EARLY DESIGN GUIDANCE #2

AMERICAN CAMPUS COMMUNITIES

4555 ROOSEVELT WAY NE
SEATTLE, WA 98126

DPD NUMBER: 3015513
NORTHEAST DRB MEETING: 02/24/2014

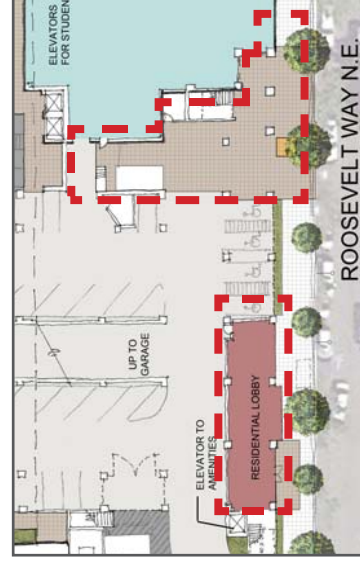
EDG #1 Board Comments

- (A1) Street Frontage on Roosevelt
- Add a primary residential lobby
 - Replace 9-10 parking stalls with commercial.
 - Add a generous grocery plaza

(C4) Materials

- The lattice screening should not appear as a cheap or simple mask. The project should use important portals and vertical counterpoint at key locations such as corners, lobbies and entries.

- (A1) Street Frontage on Roosevelt
- The primary residential lobby is fronting the south-east street edge on Roosevelt Way.
 - The primary residential lobby replaces the existing parking stalls from mid-lot to the southeast corner.
 - The grocery plaza is fronting the Roosevelt Way with two handicapped stalls in between the plaza and the residential lobby.

(C4) Materials

- The lattice screens integrated to the design of the existing and new building. It will be made of metal frames that are durable and esthetically pleasing. The concept of the project includes portals along the east façade and vertical corner embellishments.

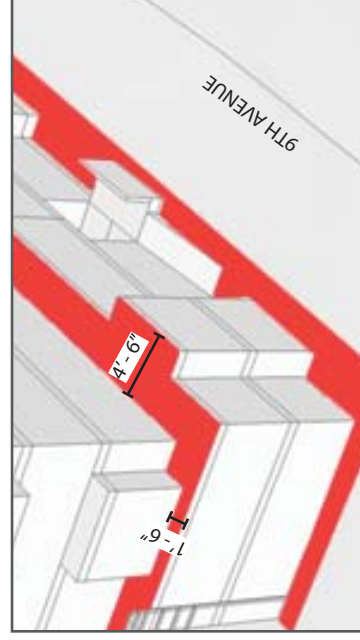
- (A2) Upper level setback
- Add upper level step-backs along 9th Ave, approximately 2-3 stories
 - Add upper level step-backs along the zone-change on 47th St

- (A2) – Upper level setback
- The upper residential floors along 9th avenue steps back to provide spatial relief for the residential street. The townhouses along the street edge bring the overall building mass to a residential scale and relate to the residential neighborhood.

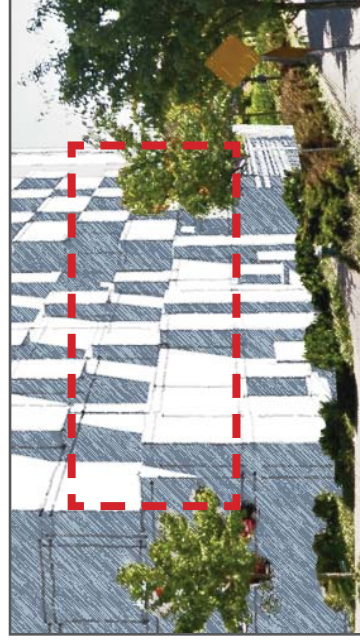
- (A8) Parking and Vehicle Access
 - The project should look at a more direct parking access further north freeing up the existing curved access to the plaza.
- (C5) Parking Entrance
 - The portal height for the garage entrance suggested on 47th St is too tall.
- (D1) Pedestrian Open Space
 - A provision of a public plaza at eh southeast corner could provide a terminus of the mid-block walkway.
- (D2) Blank Walls
 - The project should look at enhancing all existing blank portions with artful surface treatments.

- (A8) Parking and Vehicle Access
 - The design utilizes the existing driveway but we created a pedestrian zone to create a separation between vehicular and pedestrian circulation.
- (C5) Parking Entrance
 - The design includes screens at the parking garage opening on 47th to make the opening less apparent.
- (D1) Pedestrian Open Space
 - The mid-block pedestrian path terminates into the public plaza on Roosevelt Way to enhance pedestrian activity along the street.
- (D2) Blank Walls
 - The design incorporates the new facade over the existing building corner. The Roosevelt façade incorporates an architectural metal screening at the retail storefront and parking garage that extends up to blend the upper levels. The feature will provide a retail esthetic feature for the public on a busy arterial.

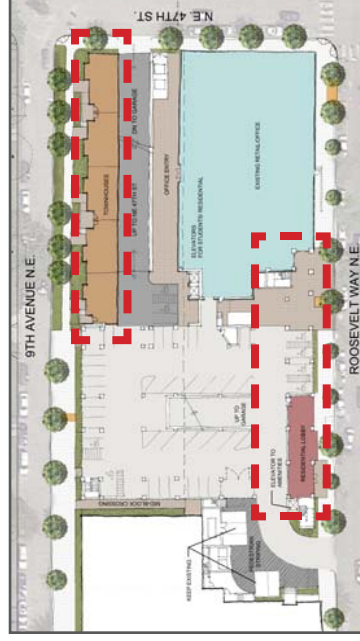
- (B1) Upper level setback
 - Step back upper floors on the north edge.
 - Step back height and scale at the northwest corner.
 - Consider adding a sizeable full-height notch/recessed plane to the north and/or west facade.
 - Consider enhancing the corner of 47th St and Roosevelt Way per A-10 to transition to the north façade. The upper level along 47th St. should step back.
- (C1) Architectural Context
 - Modulate & break up massing scale.

- (B1) Upper level setback
 - The upper residential floors are stepped 2 feet back on the north edge.
 - The upper residential floors are stepped back at the northwest corner and along the 9th Ave to reduce the scale of the building for residential street frontage
 - A rhythm of townhouses on the west façade lines the street level. The two-story bays above the townhouses provide a prominent feature along the residential street.
 - The project is proving signage and screen embellishment at the corner of 47th St and Roosevelt Way. An opening to the courtyard along Roosevelt provides a visual connection for the public and private. The upper levels are setback along 47th St.
- (C1) Architectural Context
 - The design will emphasized townhomes, the northeast corner and the storefront. The canopies will be utilized to break up the massing scale.

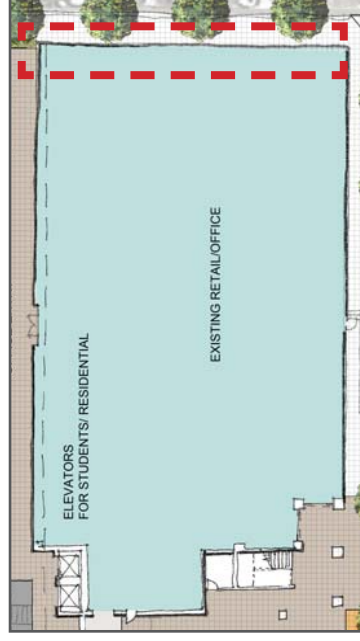
- (D6) Screening of Dumpsters, utilities, and service area
 - The "new trash" location on 47th St. will avoid being a blank wall and operations will not impact residential neighbors across the street.

- (D6) Screening of Dumpsters, utilities, and service area
 - The design shows the trash location moved to inside of the garage. Trash pickup and operations will not have any impact to the residential neighbors on 47th St.

NE CORNER SIGNATURE SIGNAGE

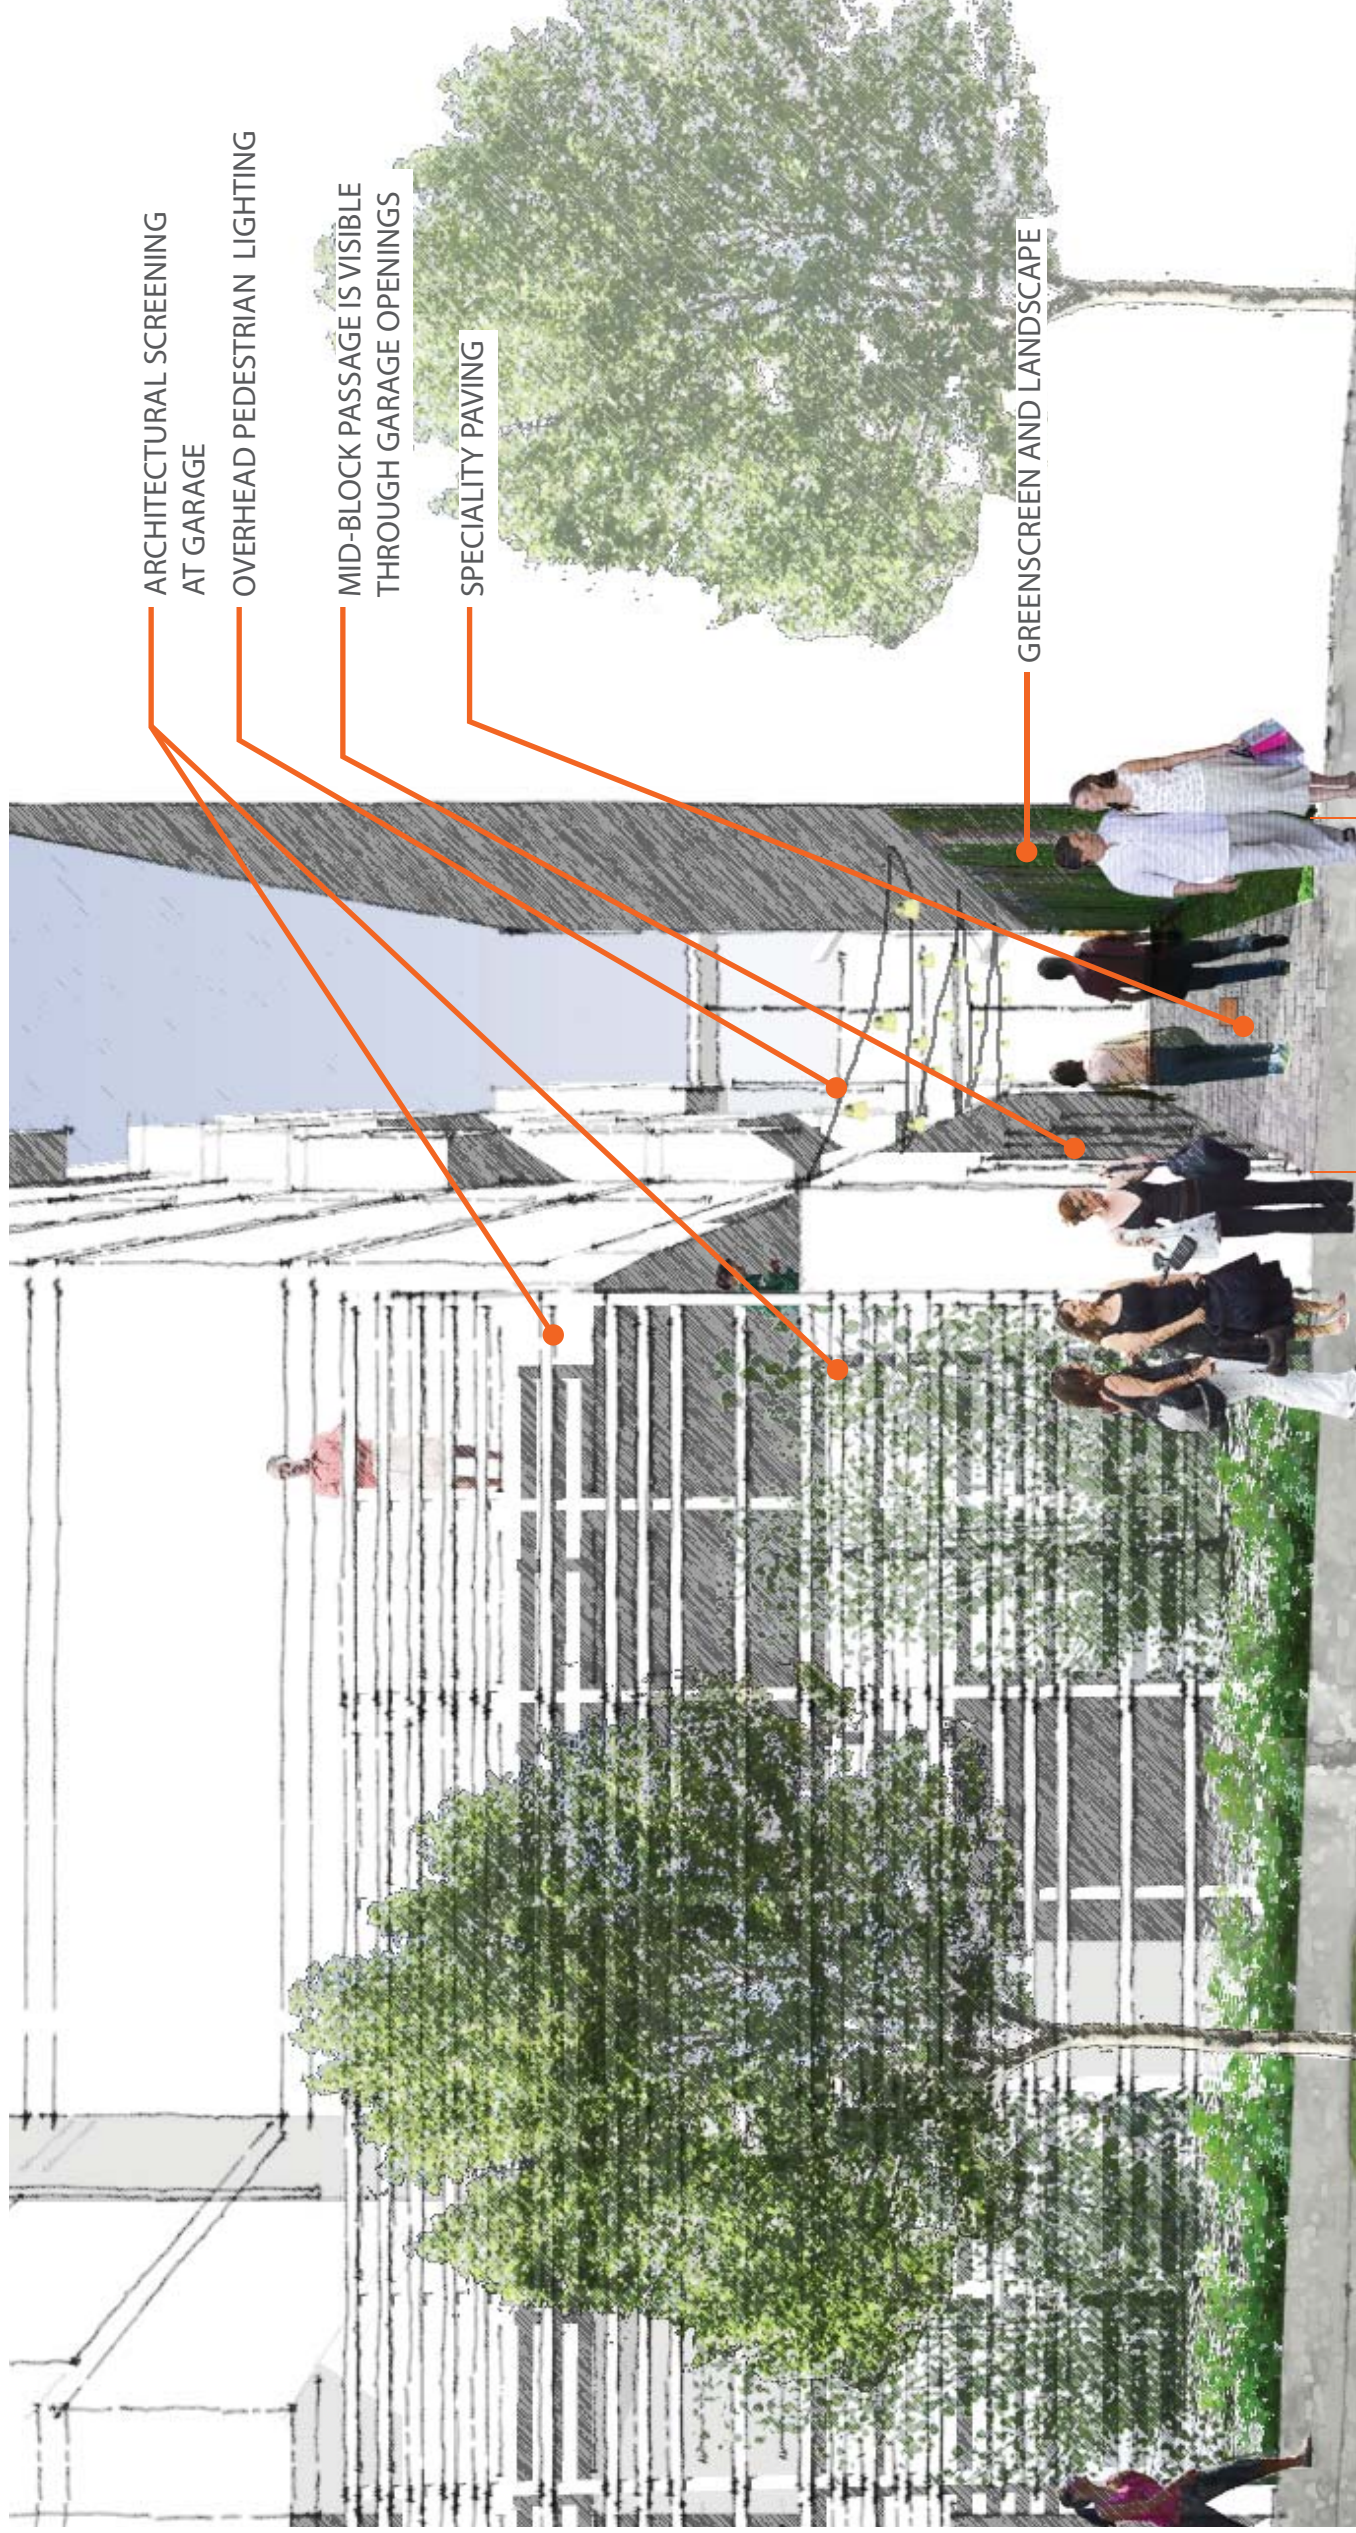
- (D9) Commercial Signage
- The existing northeast corner is very bland, and the enhancement of this corner could include well-integrated signage for the anchor grocery tenant.

- (D9) Commercial Signage
- The design incorporates signage and screens on the façade that extends from the existing building corner up to the new building. The elements integrate the existing and new facades.

A NEW 18" DEEP, 3 - STORY CORNER BAY ADDITION WITH WINDOWS, A VERTICAL SIGN AND LIGHTING WILL EMPHASIZE THE BUILDING CORNER AND ANCHOR IT TO THE STREET INTERSECTION.

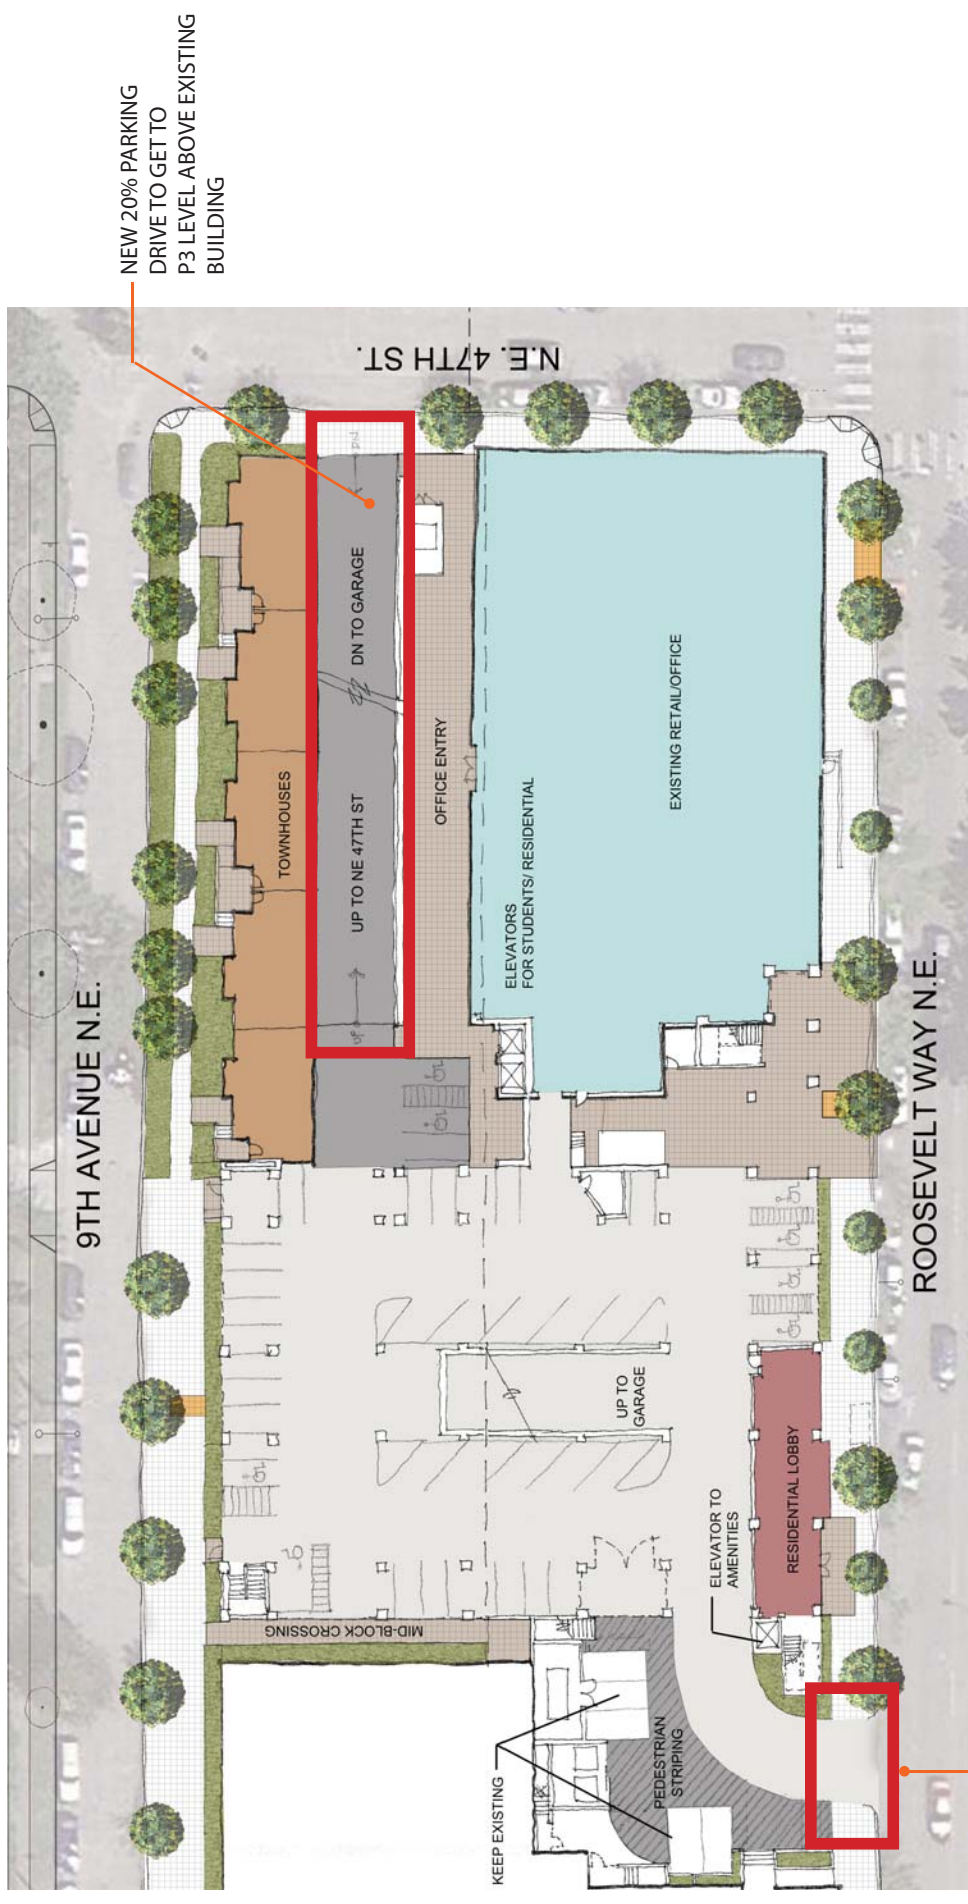
Driveway slope for all uses shall not exceed a slope of 15 percent.

For driveways that provide access to a solid waste management use the Director may allow both a maximum driveway width greater than the limits set in subsection 23.54.030.D.2.a and appropriate turning path radii, as determined necessary for truck maneuvering.

Response: Increasing the slope of the ramp off NE 47th Street to 20% will allow a straight run for vehicles to enter and exit the parking located on the existing roof structure above the office and Trader Joes. This minimizes the number of complicated vehicle turning movements required within the garage structure and improves safety and visibility.

Response: Director to provide greater limit for driveway off of Roosevelt to allow for solid waste management.

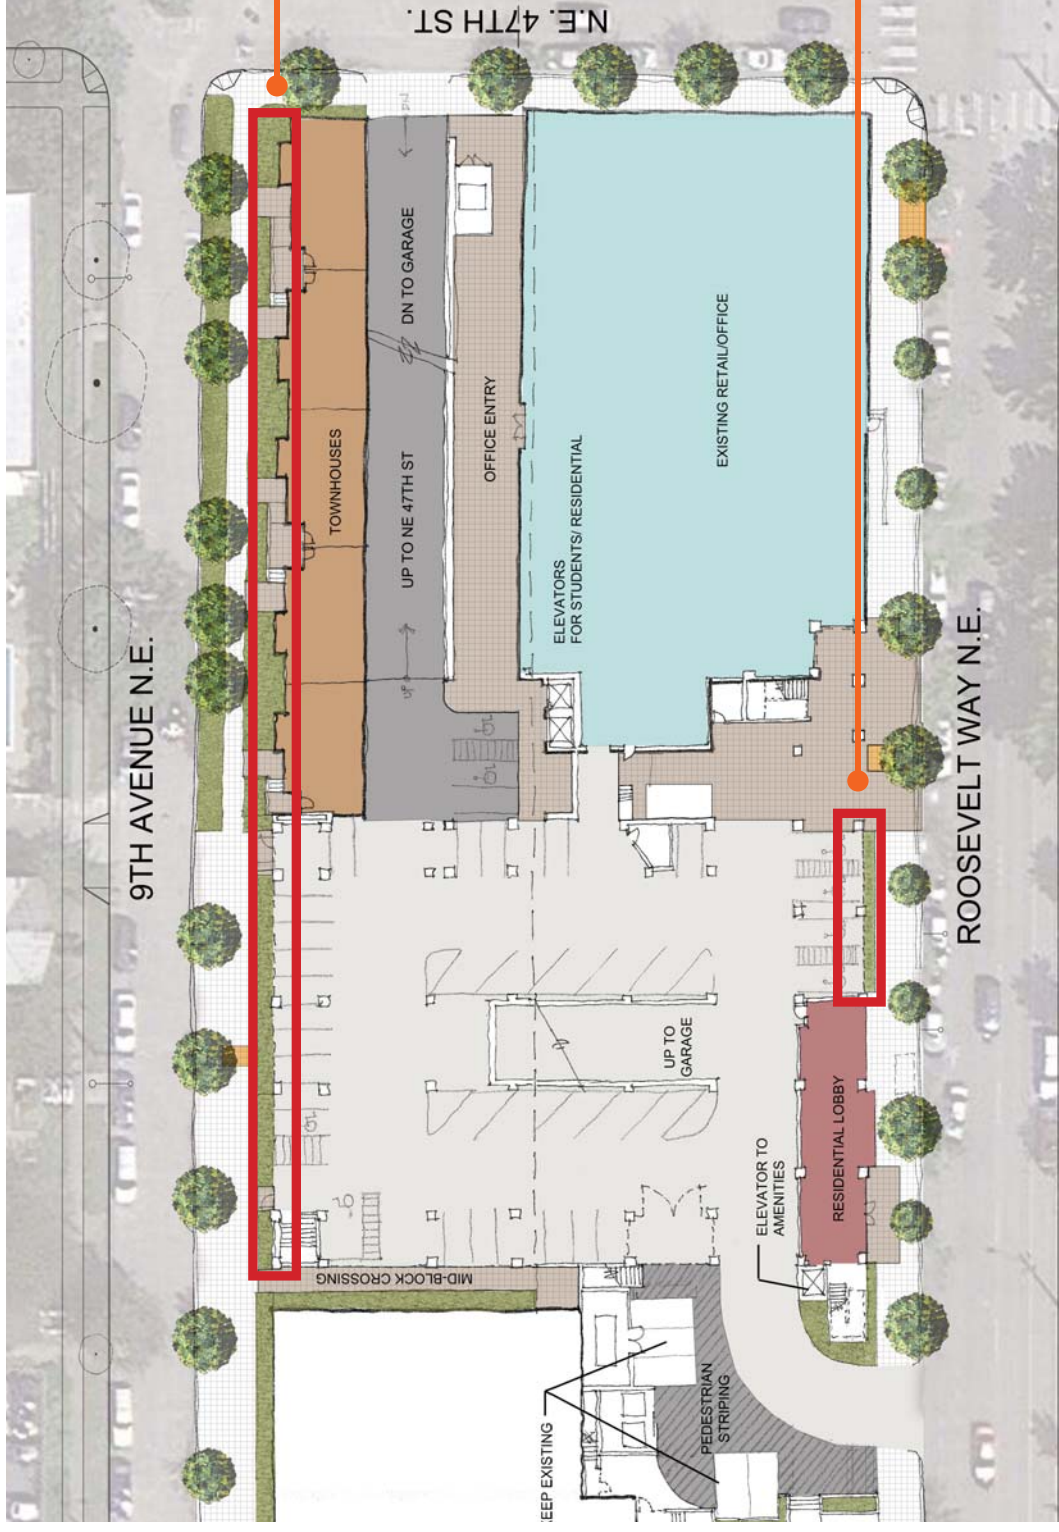
For two way driveways or easements 22 feet wide or more, a sight triangle on the side of the driveway used as an exit shall be provided, and shall be kept clear of any obstruction for a distance of 10 feet from the intersection of the driveway or easement with a driveway, easement, sidewalk, or curb intersection if there is no sidewalk. The entrance and exit lanes shall be clearly identified.

The sight triangle shall also be kept clear of obstructions in the vertical spaces between 32 inches and 82 inches from the ground.

Response: There are existing trees and light poles

Response: There are existing site items.
